Addendum No. 2
October 16, 2023

Project: **Harrisburg South Middle School Theatre Addition**
Harrisburg, South Dakota
Architecture Incorporated Project #3024

Scope of this Addendum:

SECTION DETAILS

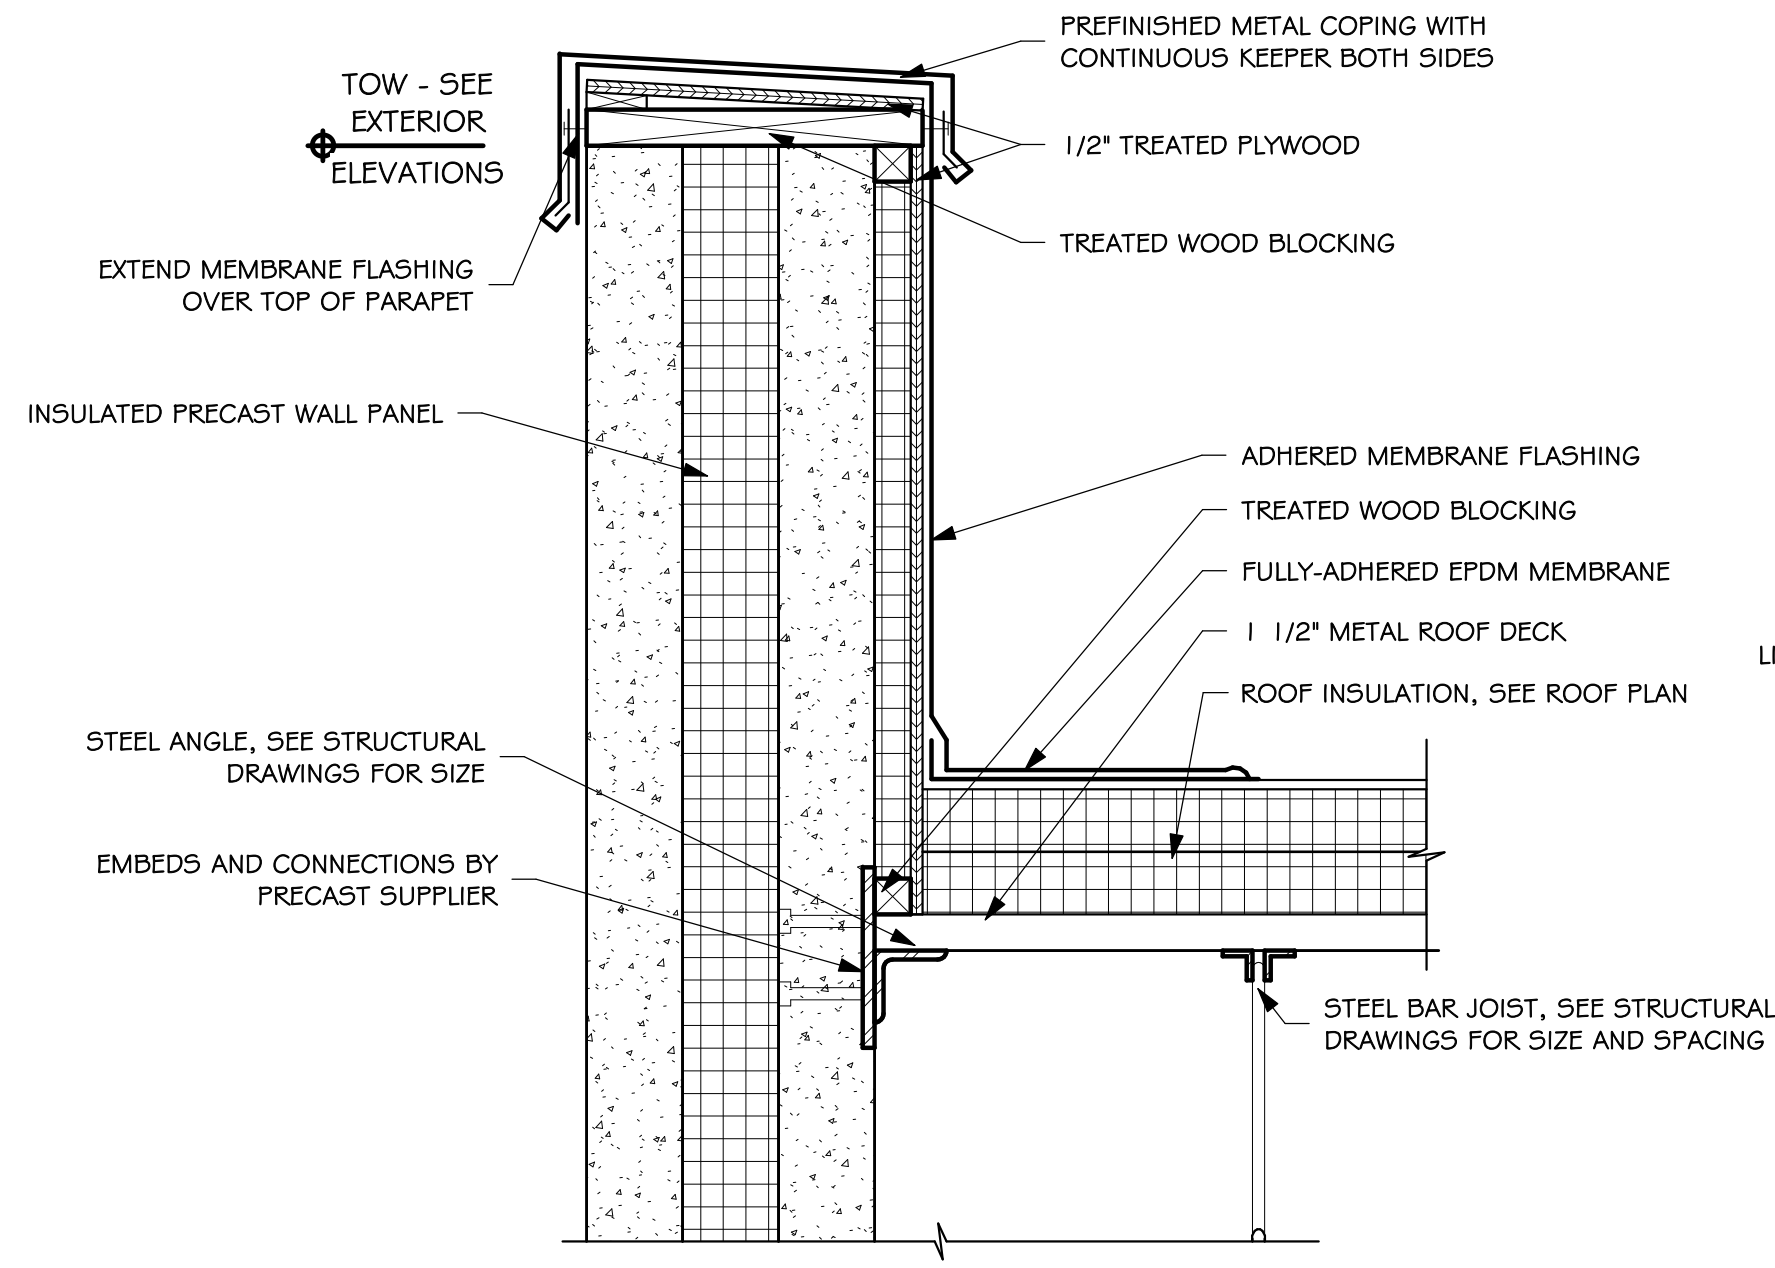
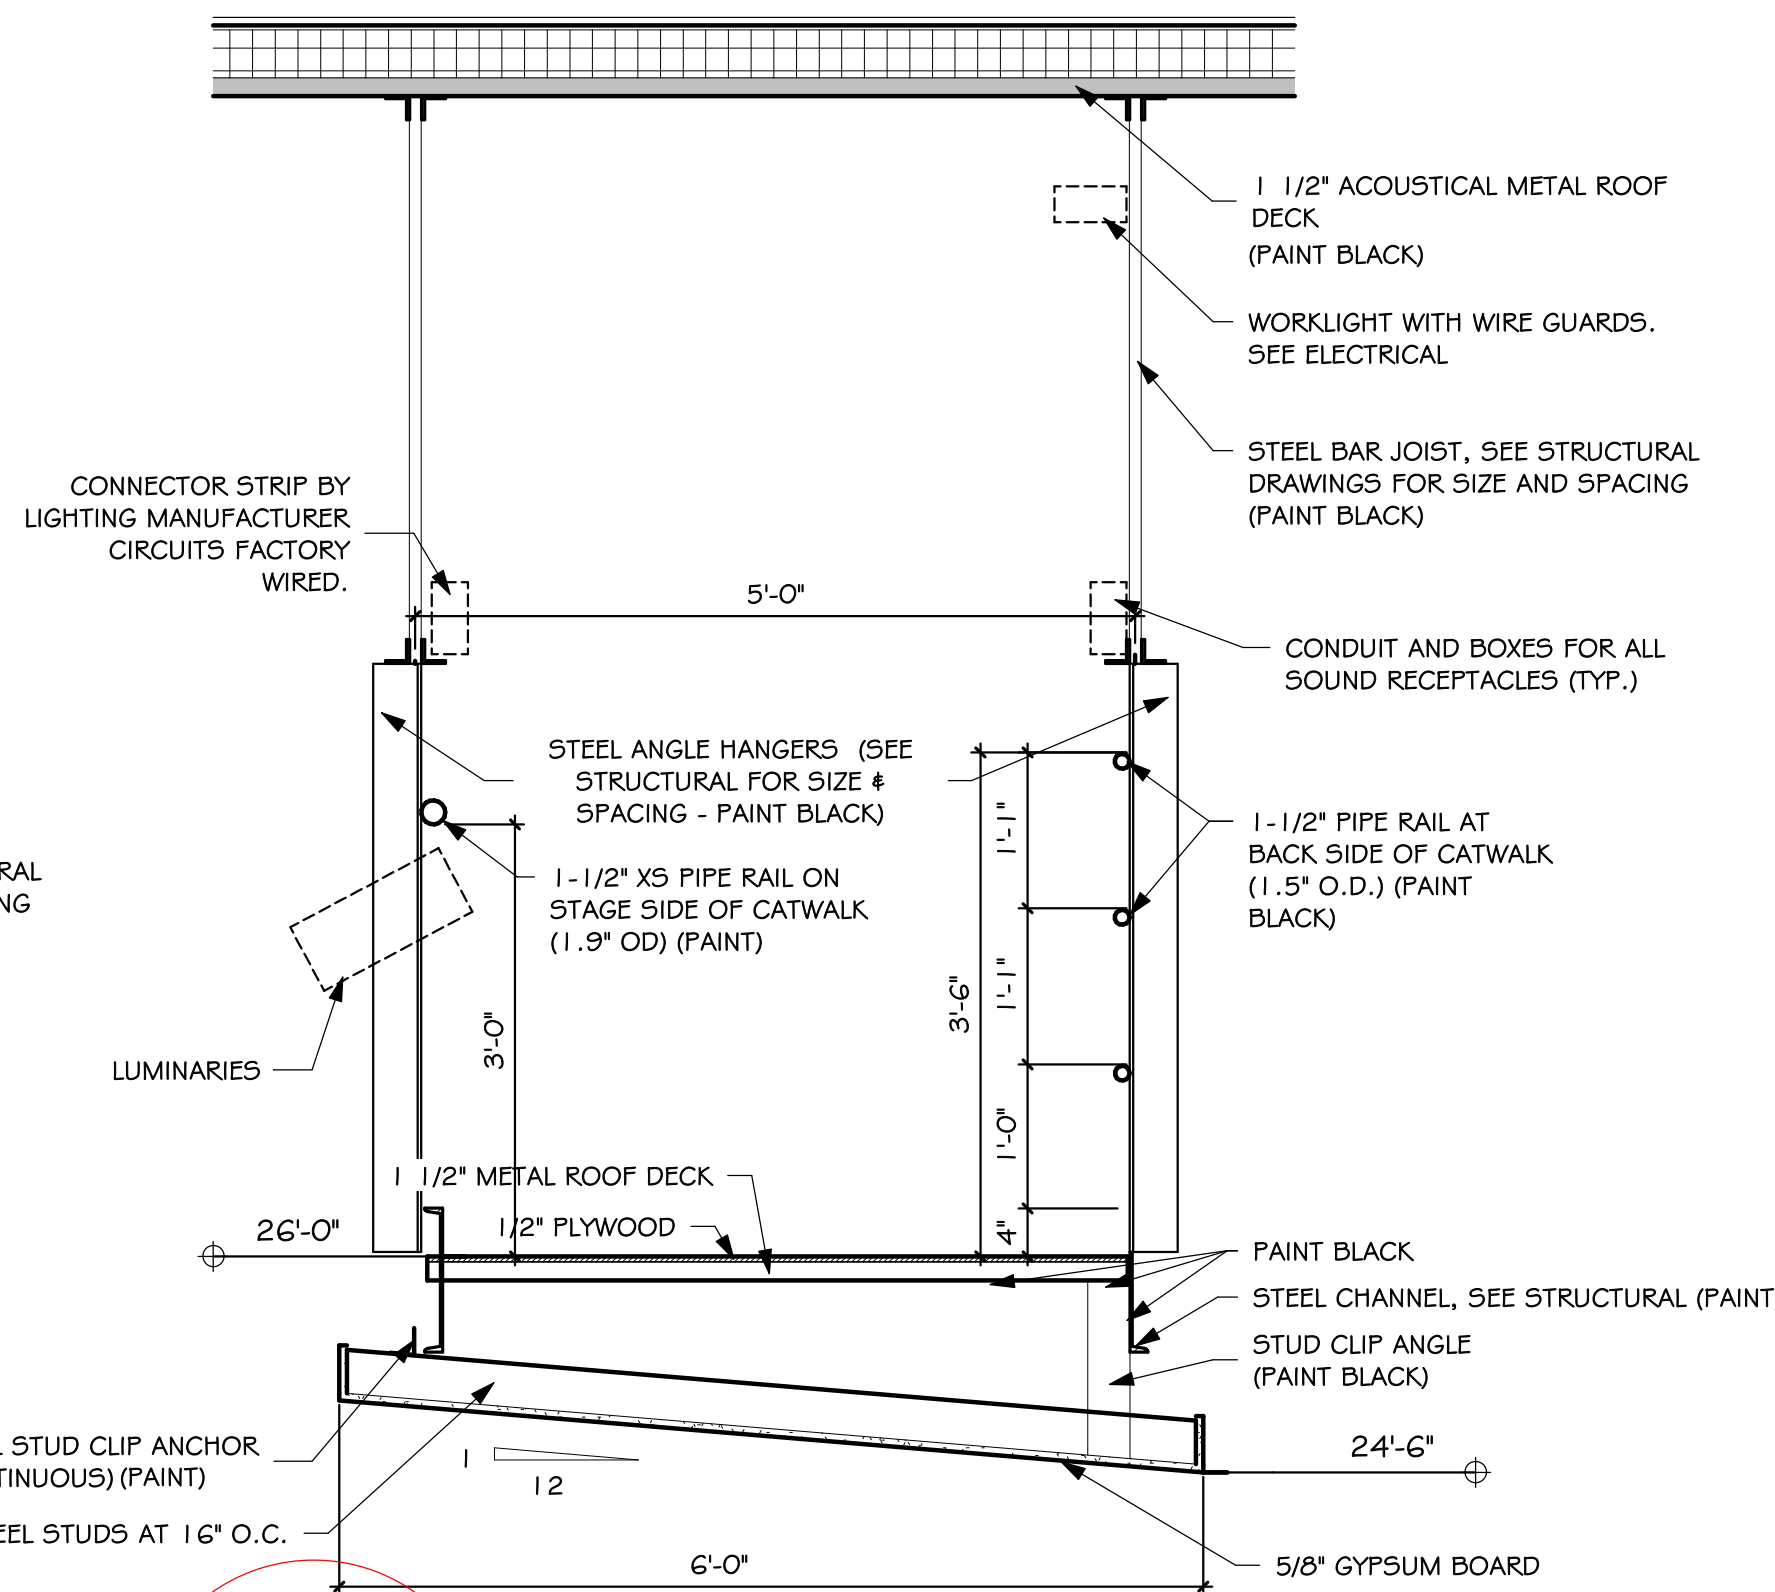
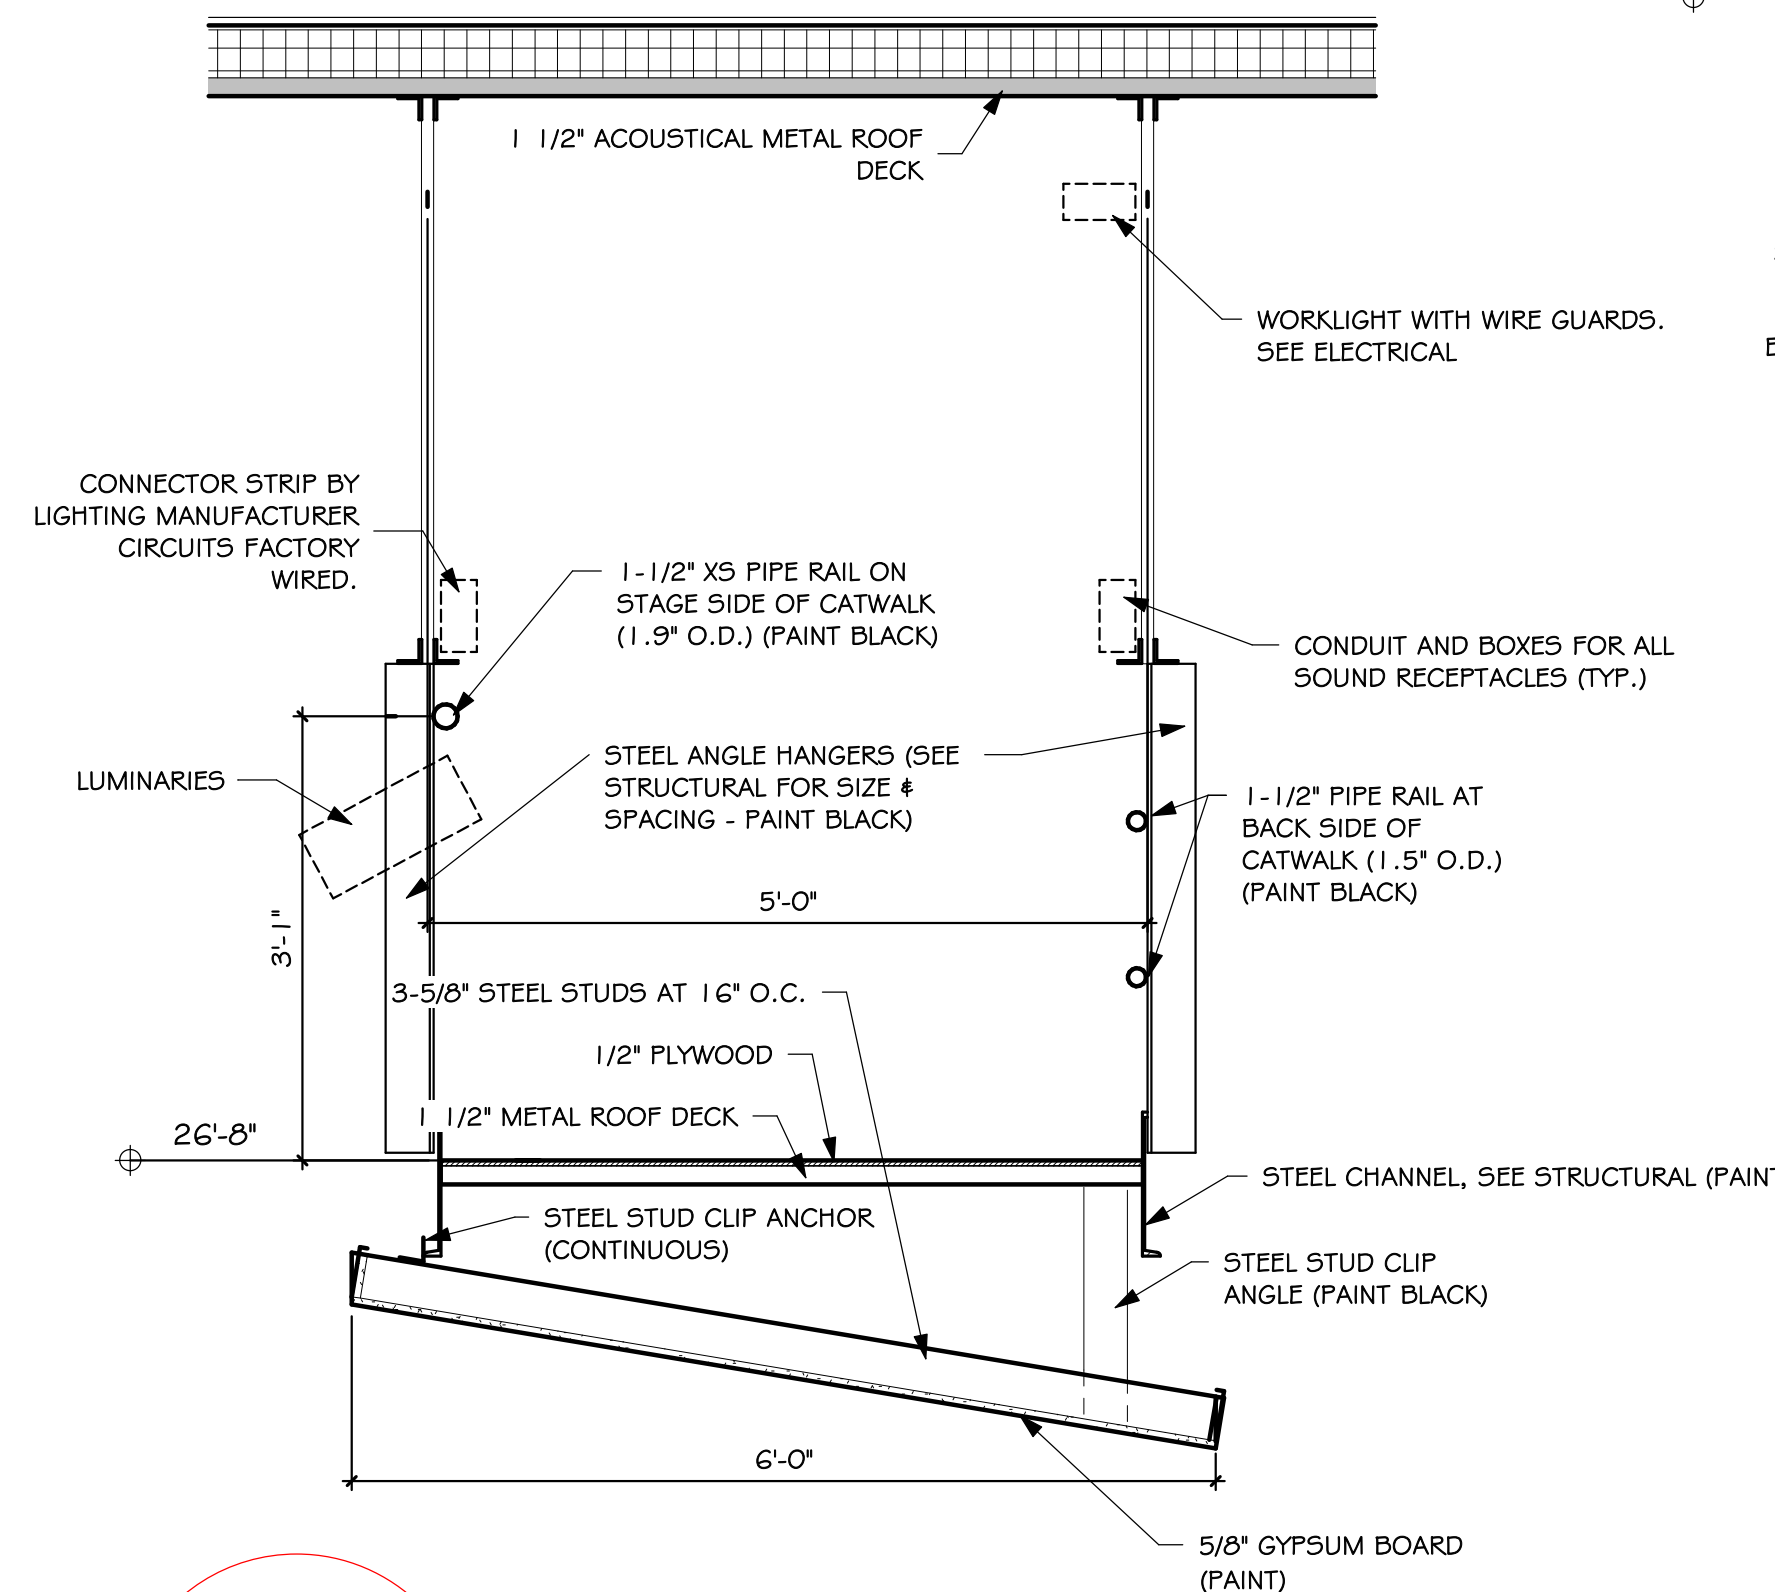
- a) See attached revised drawing 5.41 Section Details with revision date of 10-16-23 for the following revised details:
 - i) Catwalk detail 2/5.41
 - ii) Catwalk detail 3/5.41
 - iii) Detail 6/5.41 (Follow Spots catwalk at back of theatre).
